**Rockwall ISD – Updated Site Plans for Ninth Grade Center Projects:
SP 2022-17 (FM1141& Quail Run) & SP2022-18 (John King Blvd at GBCCA)**

TO: Planning and Zoning Commission
FROM: Bethany Ross; *Planner*
DATE: August 30, 2022
SUBJECT: MIS2022-018; *Exceptions Related to a Public Secondary School at 2852 FM-1141*

CASE CAPTION: Discuss and consider a request by Robert Howman of Glenn Engineering Corp. on behalf of William Salee of the Rockwall Independent School District (RISD) for the approval of a Miscellaneous Case for Exceptions associated with a Public Secondary School on a 76.068-acre tract of land identified as Tracts 14-01 & 14-11 of the J. M. Glass Survey, Abstract No. 88, City of Rockwall, Rockwall County, Texas, zoned Planned Development District 94 (PD-94) for limited Neighborhood Services (NS) District land uses, addressed as 2852 FM-1141, and take any action necessary.

LANDSCAPE PLAN AREA C

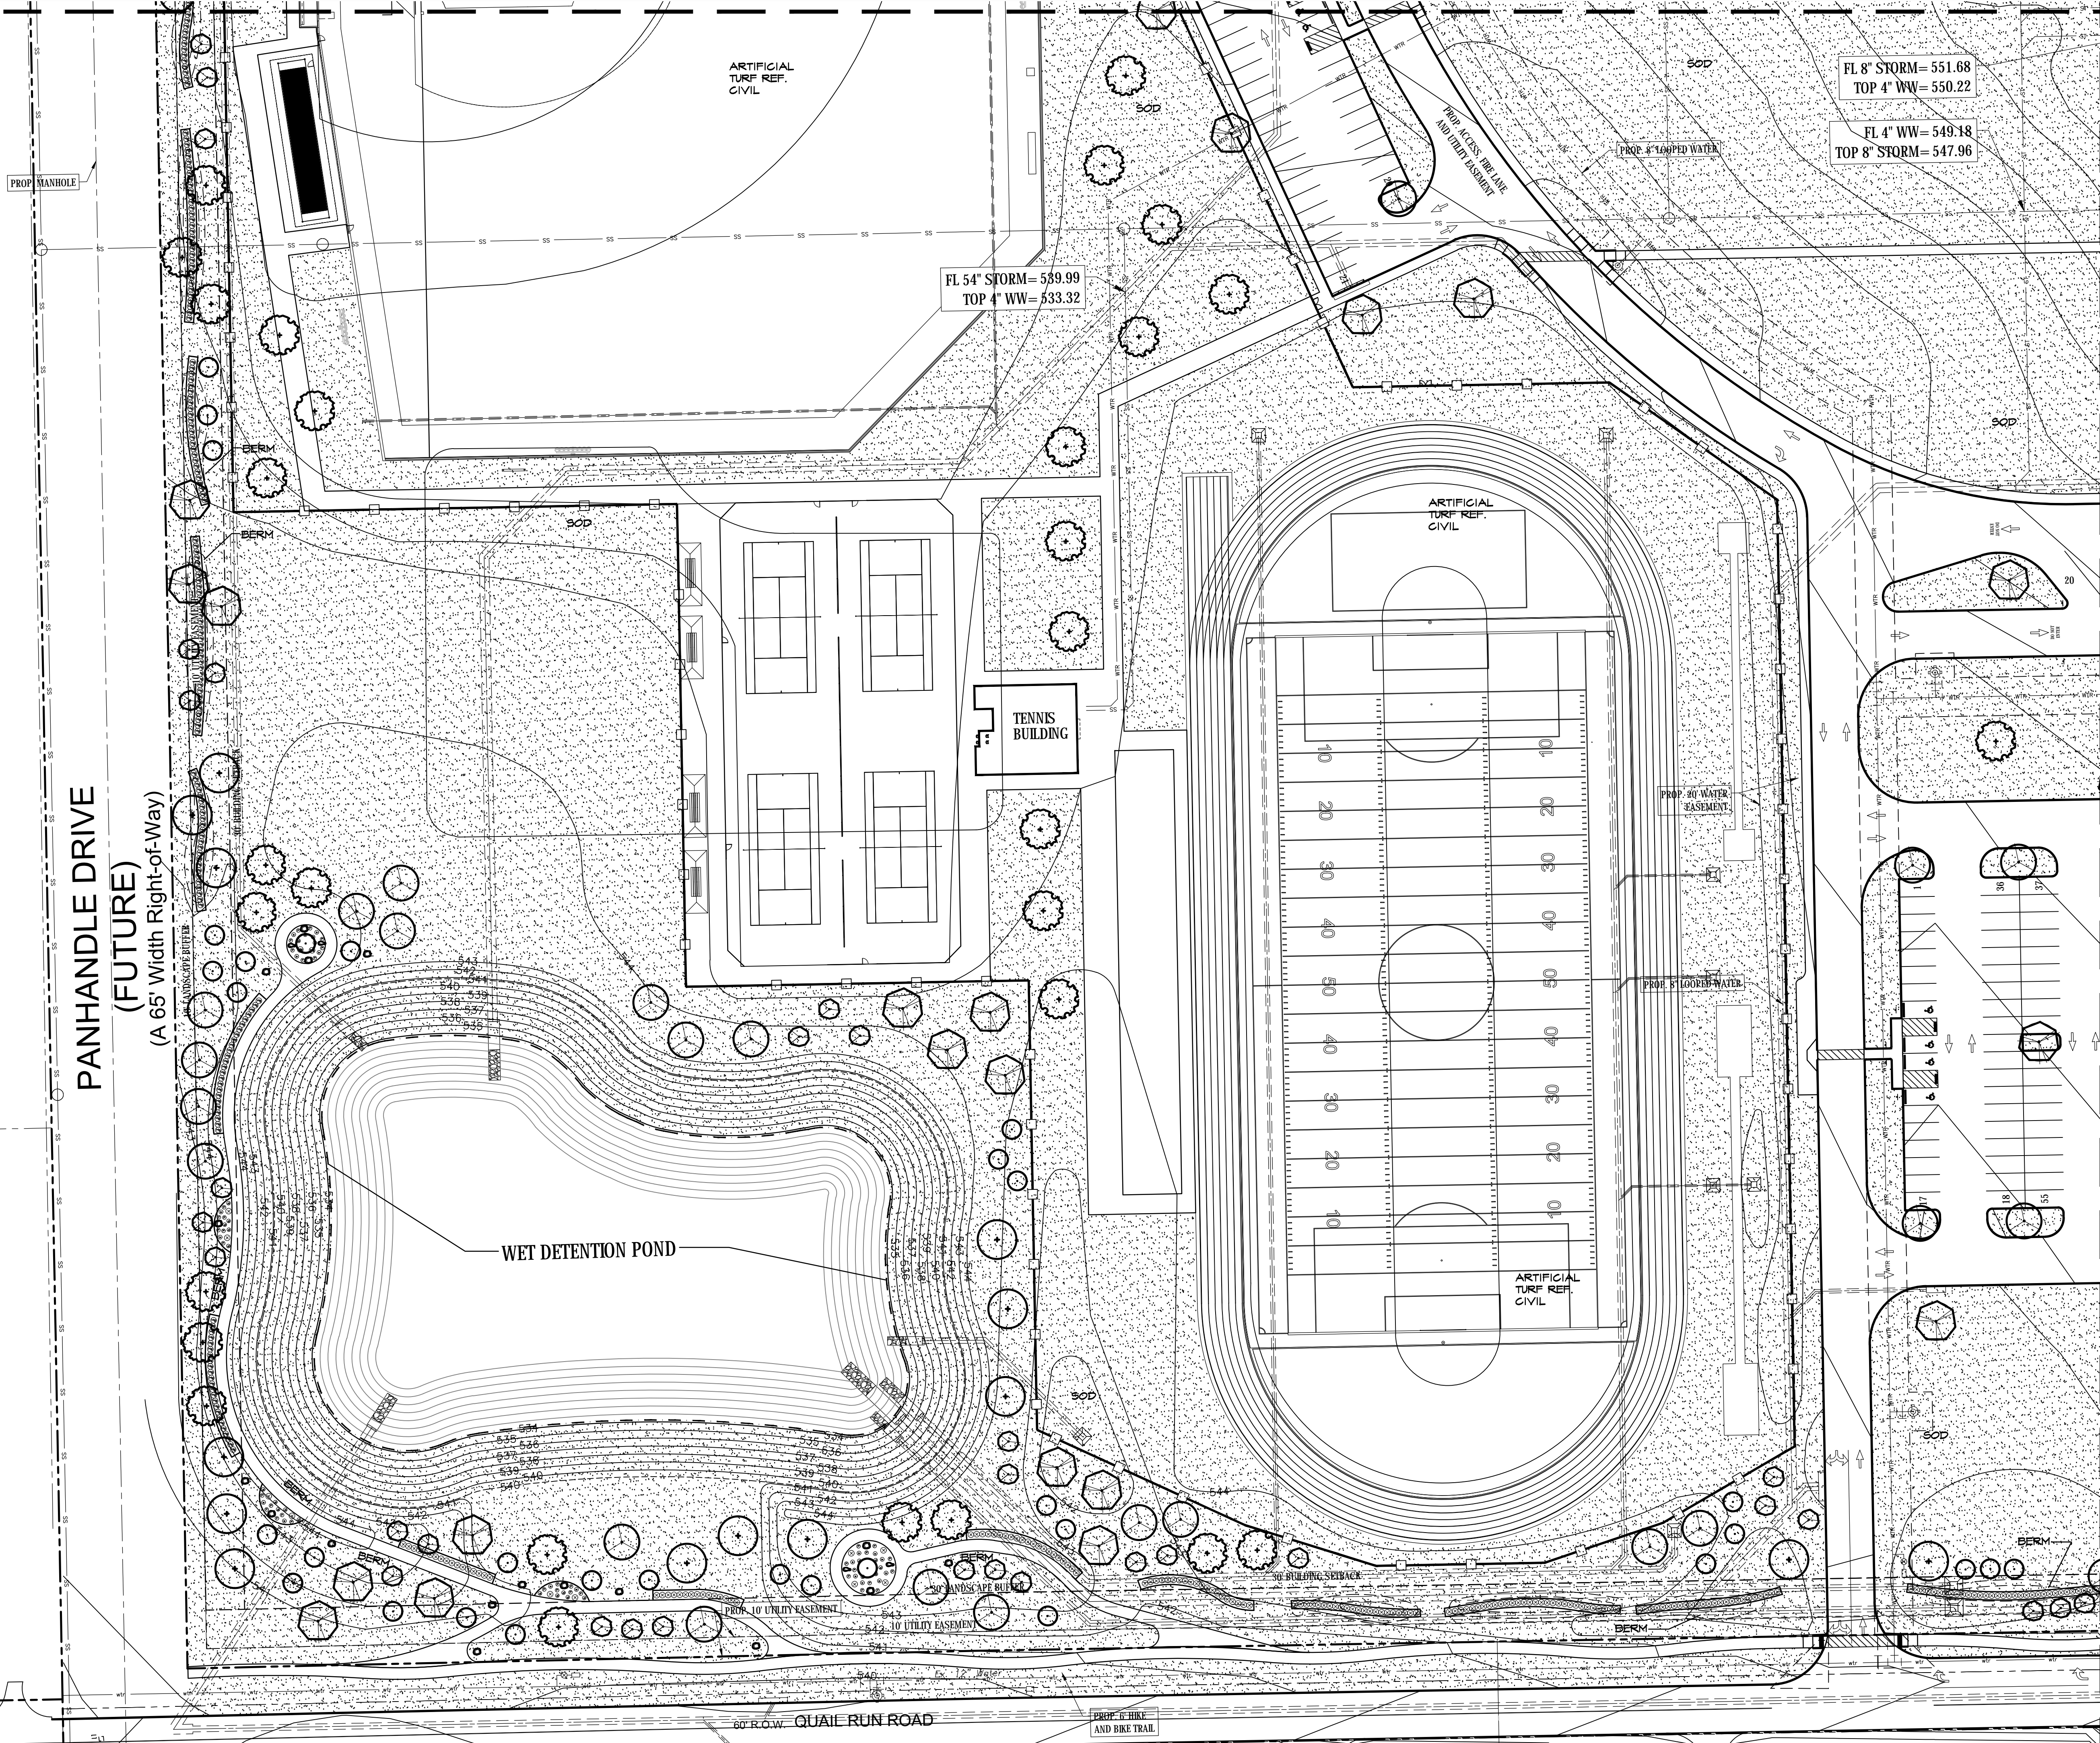
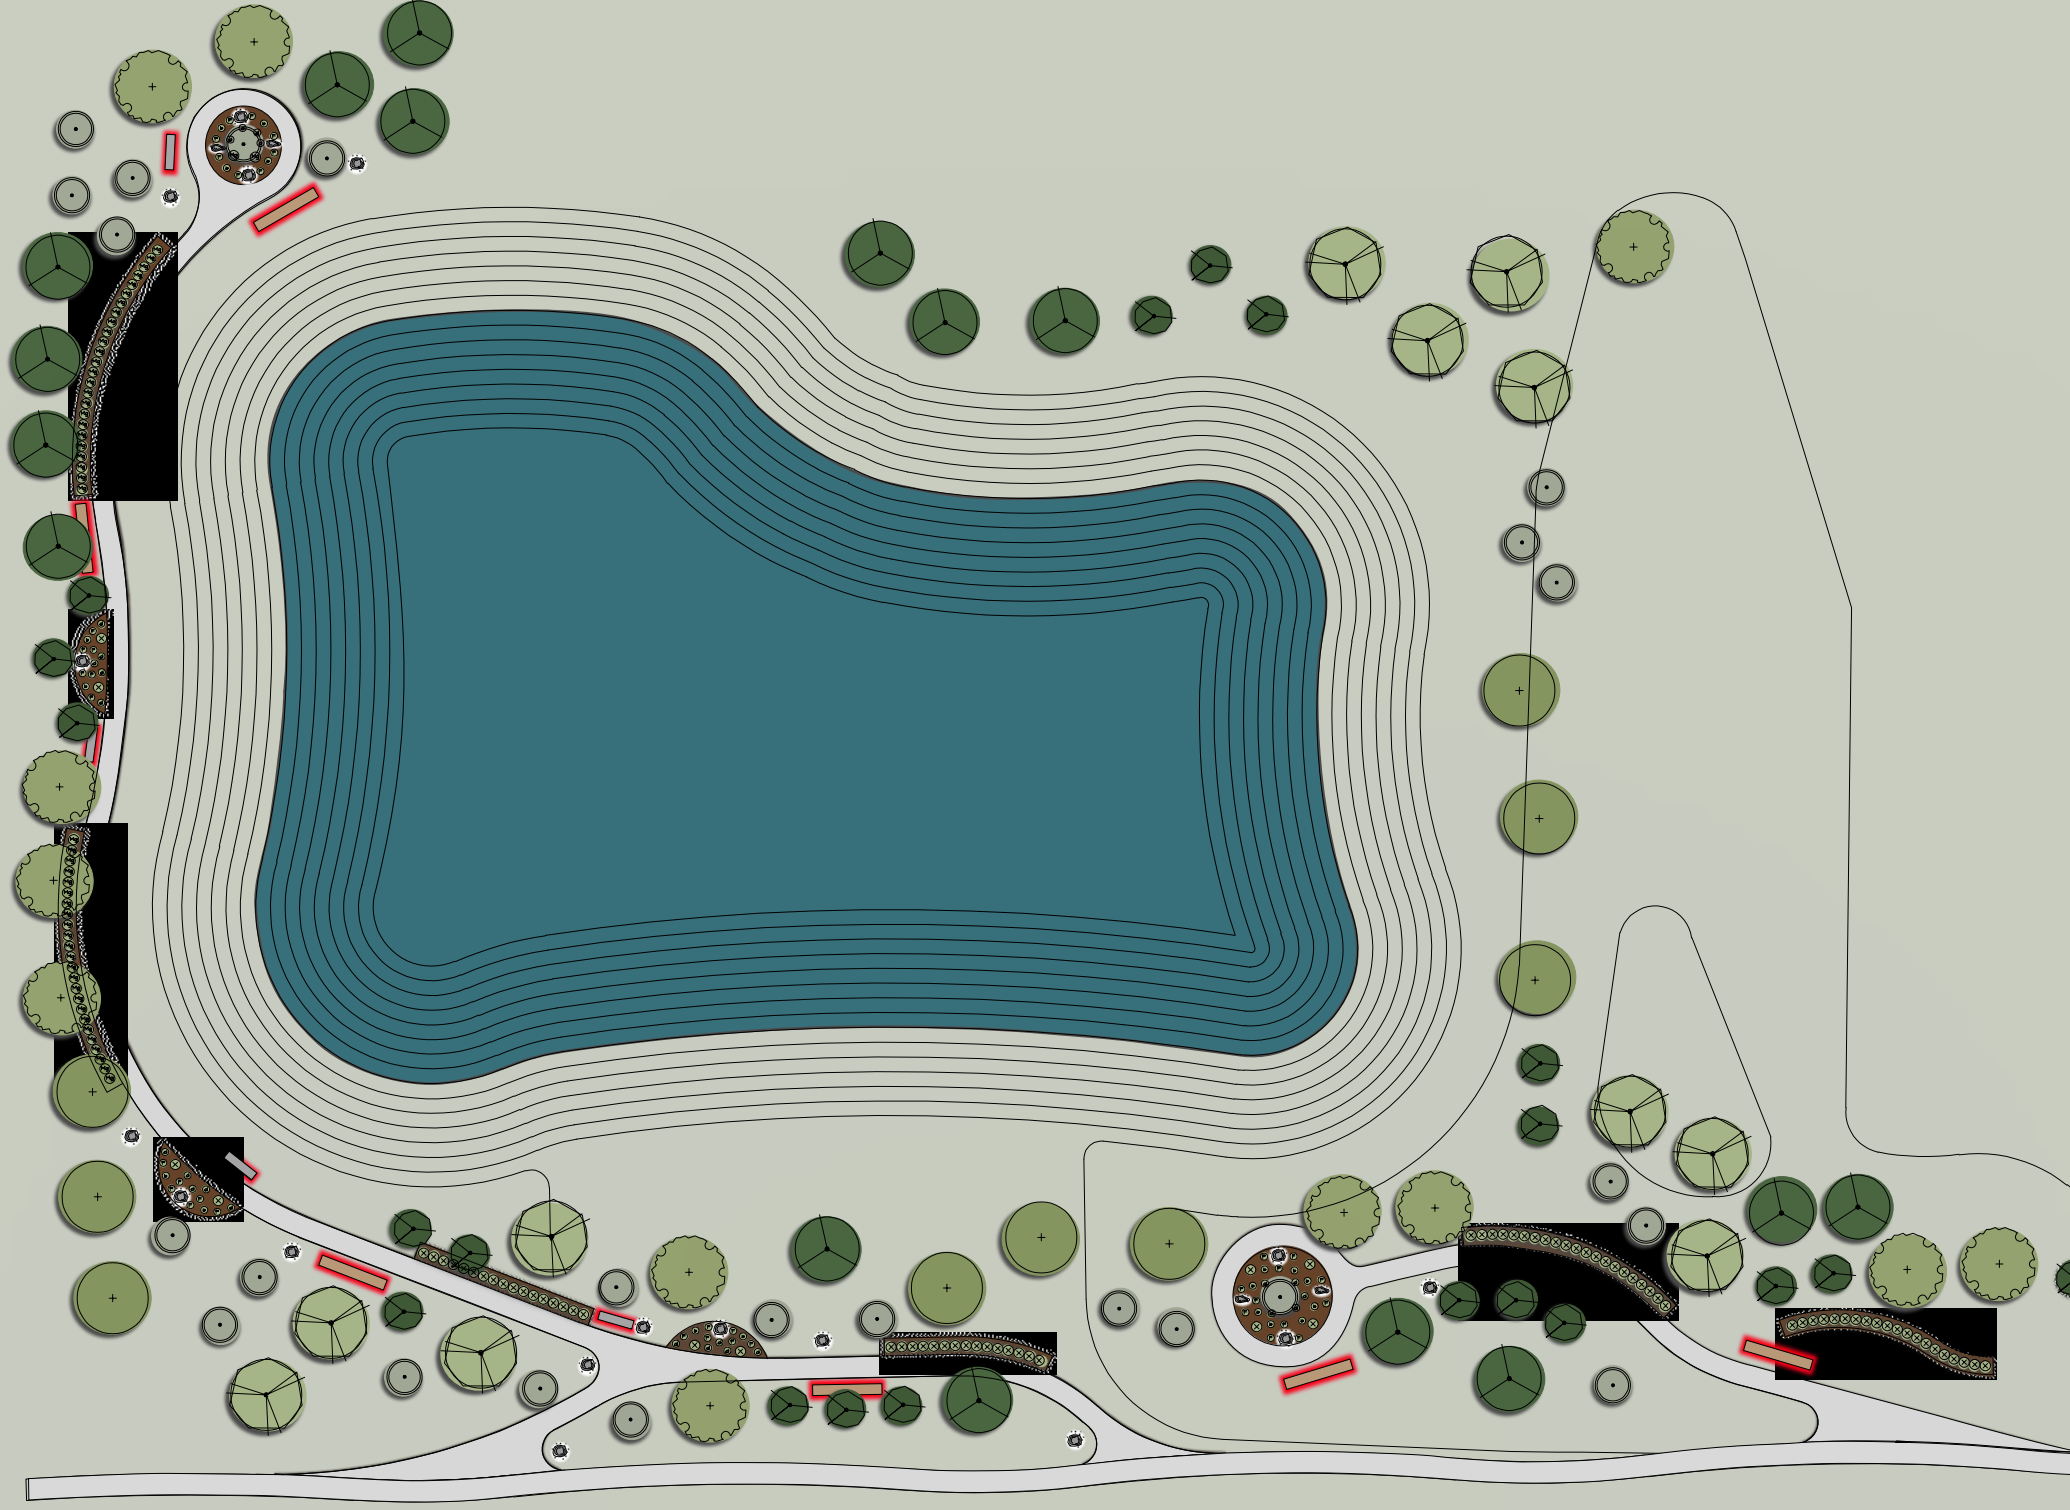
- (1) *The applicant will need to provide an updated Landscape Plan showing one (1) canopy tree per 750 SF of detention area and one (1) accent tree per 1,500 SF of detention area.*
- (2) *The applicant must request an exception for any light pole greater than 30'-0" in height per Subsection 03.03.D, of Article 07*

Rockwall ISD is requesting a partial variance for consideration by the Planning & Zoning Commission. The space available around the perimeter of the detention pond is limited due to the required location on the site for these detention areas. At both sites, 3-tiered screening elements are adjacent to the detention areas limiting the amount of trees that can feasibly fit around and near the detention basin. Forcing trees in this area will create a scenario where tree canopy growth will inhibit any ground cover, reduce tree health, and increase the likelihood of erosion due to the lack of groundcover. All other required trees for the 3-tier screening and required parking lot trees are shown to be provided and we will be in compliance. As a result, the district is asking for the following variance:

Number of Required Detention Trees: (155) Number of trees proposed to be planted: (101)
Omit (36) Canopy Trees & (18) Accent Trees related to detention area requirements.
Approximate percentage of detention trees requesting to omit: (35%)

Rockwall ISD is submitting updated landscape plans showing the number and location of proposed trees to include in regards to the detention areas. The North plan submitted with this letter includes the required landscaping along the Panhandle Drive right of way as required.
